4623906 – Low Level Chlorine Intake

POST SITE VISIT QUESTIONS AND ANSWERS

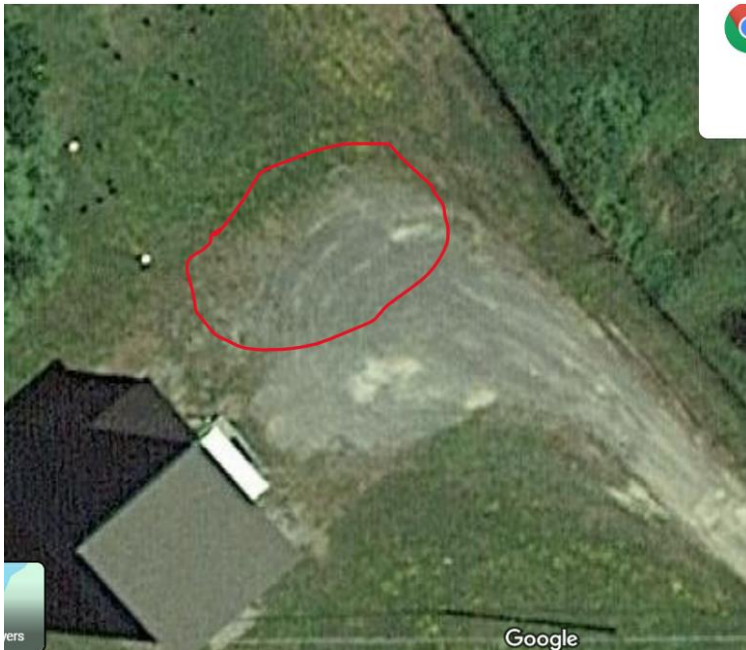
2. Can the bypass for the intake of raw water be constructed in the door of the existing facility?

Answers: Yes.
